**BLANDAIR REGIONAL PARK - PHASE 1 BUILDING CONTRACT**

Project: Blandair Park - Phase 1

R.F.I Number: 038

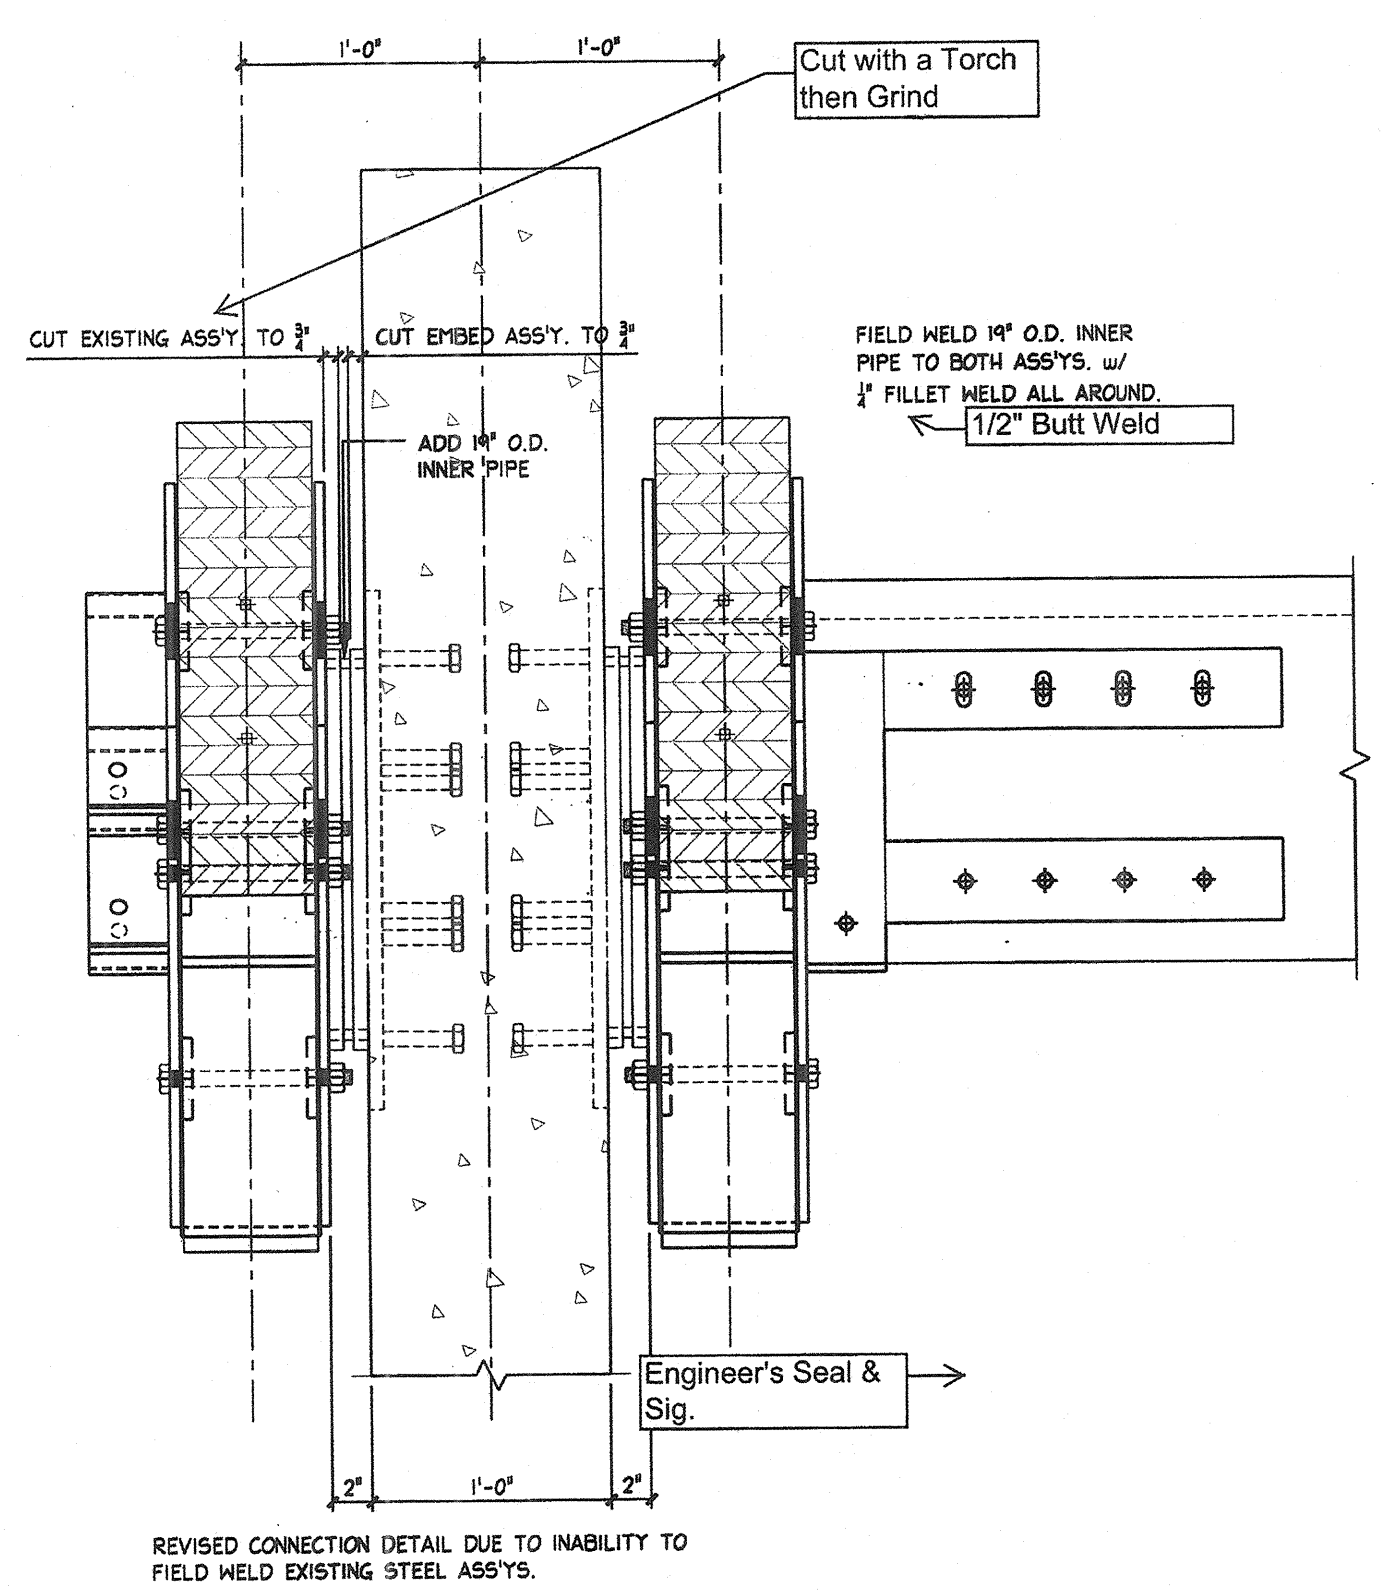
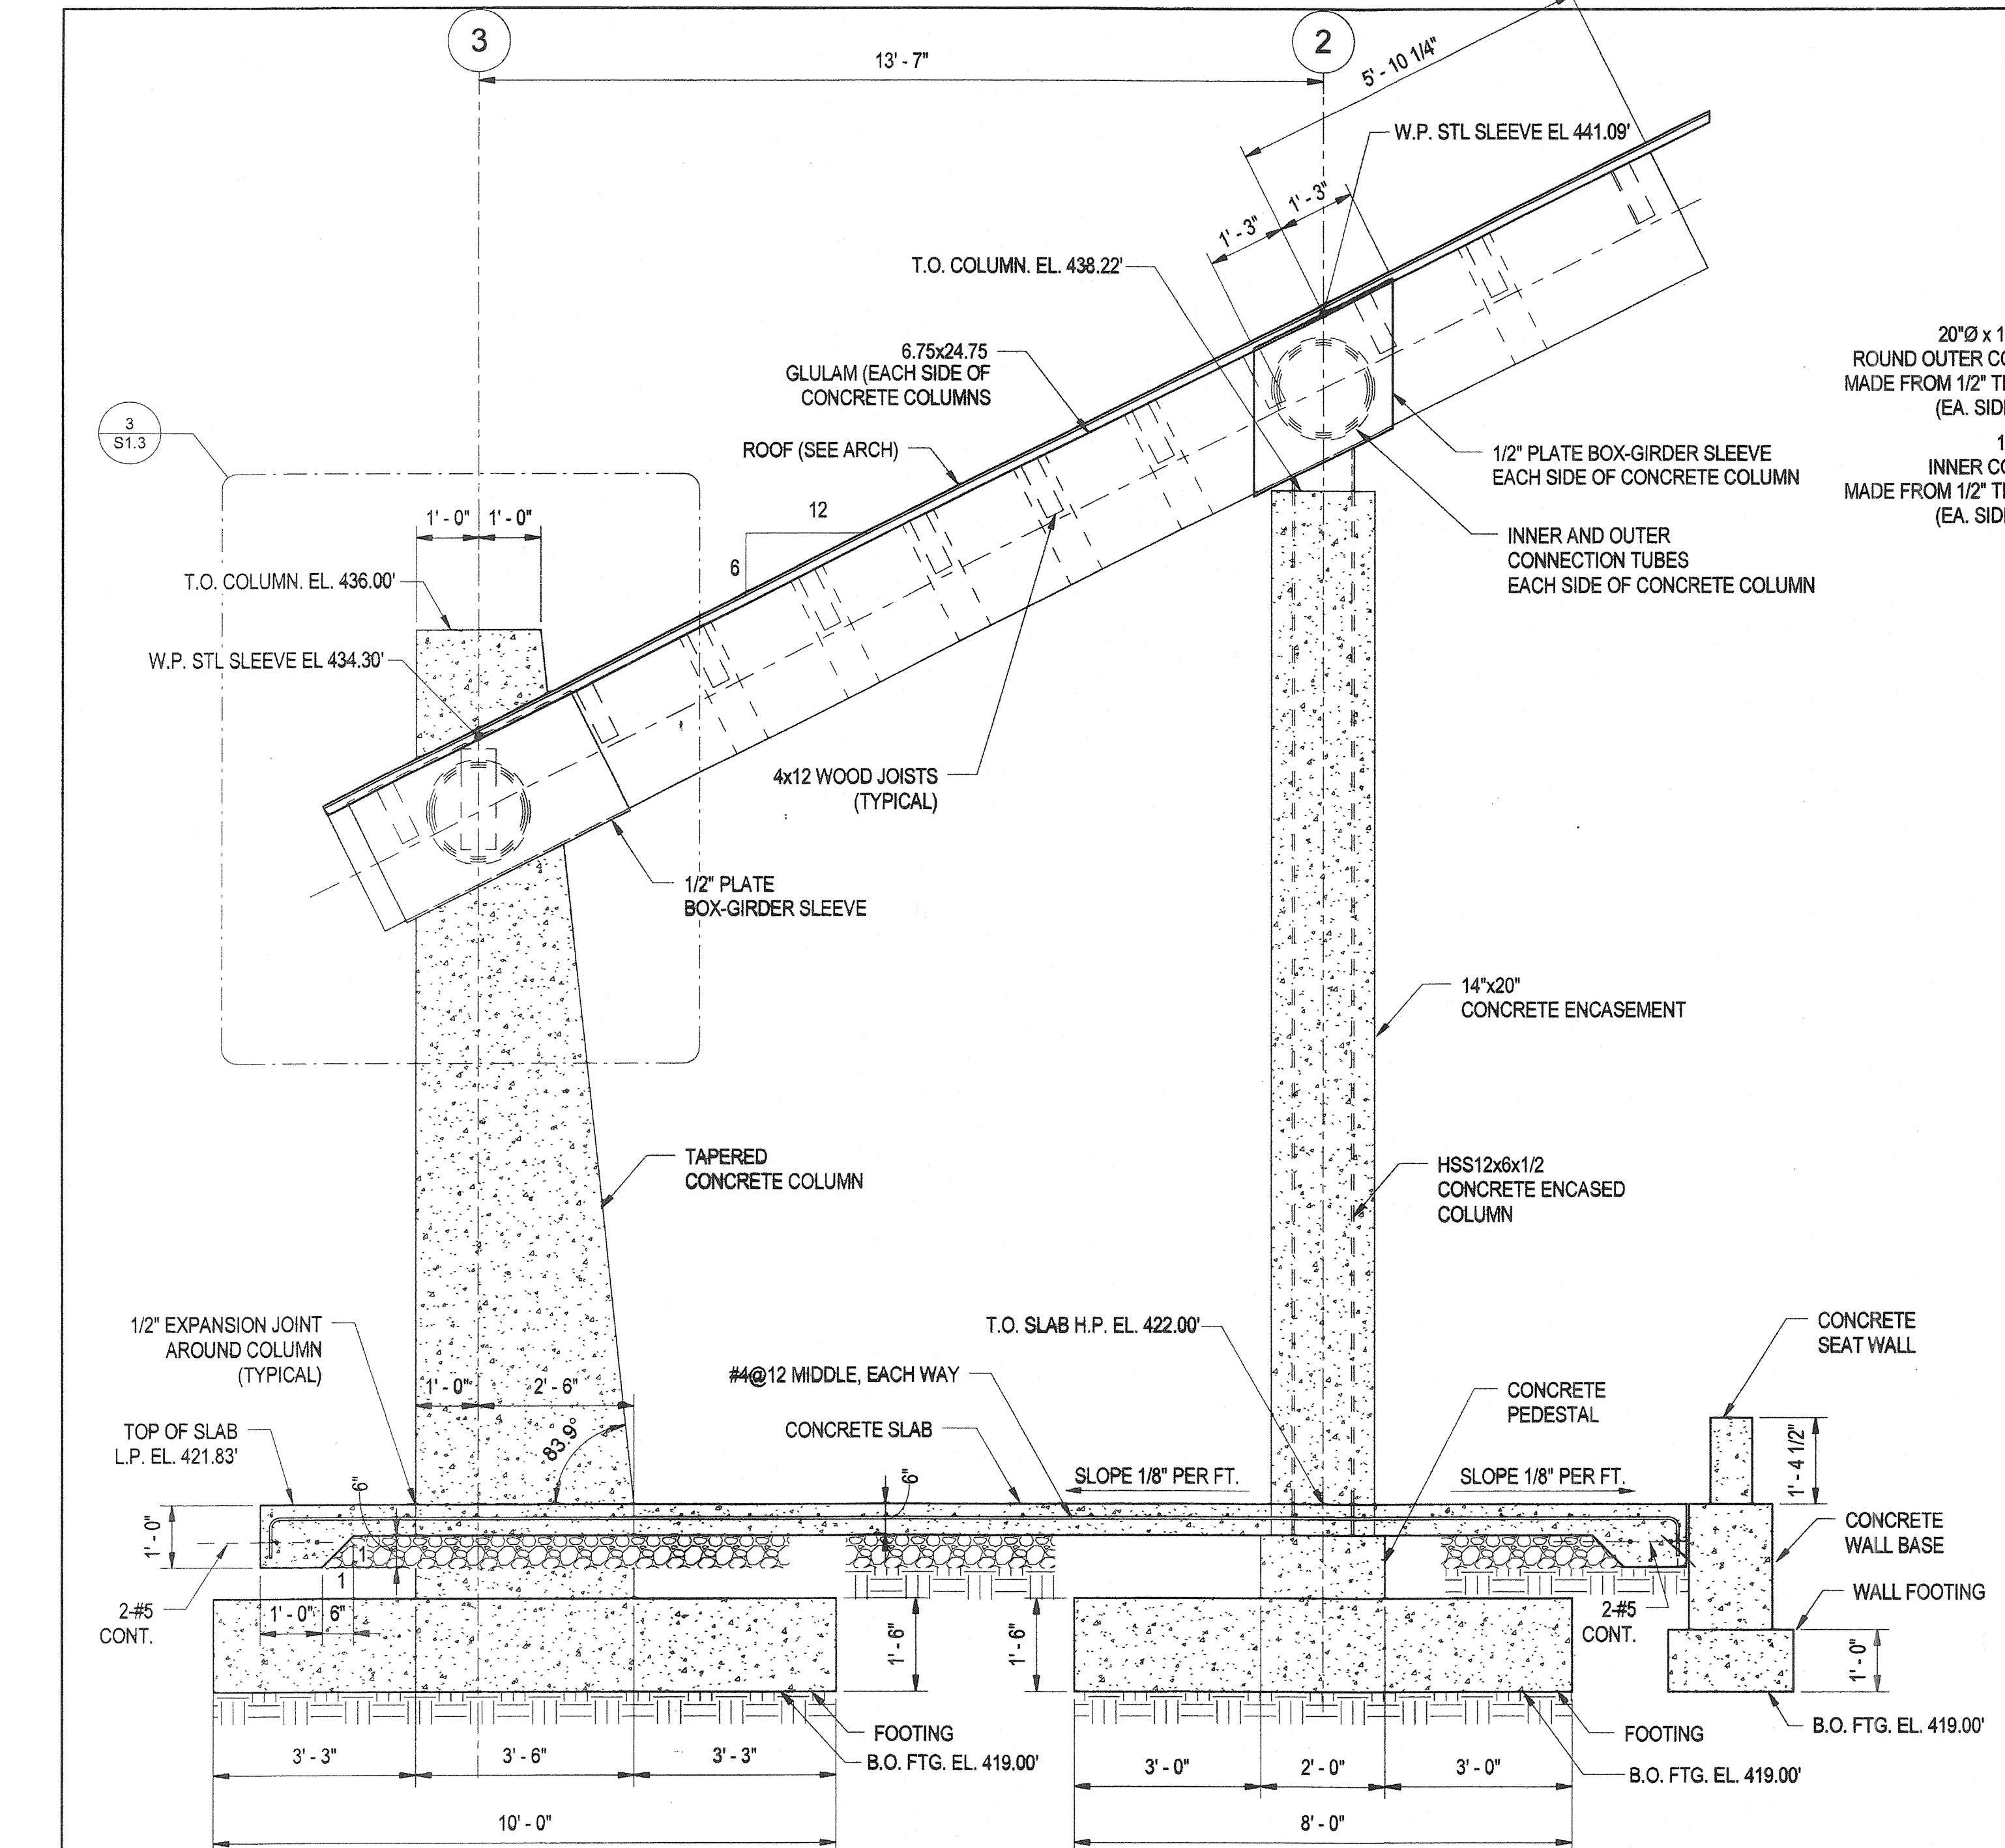
Can we use shear plates at bolt connections for timber girder to girder sleeve connection?

It is acceptable to use shear plates at the bolted connections for timber girder to girder sleeve connection.
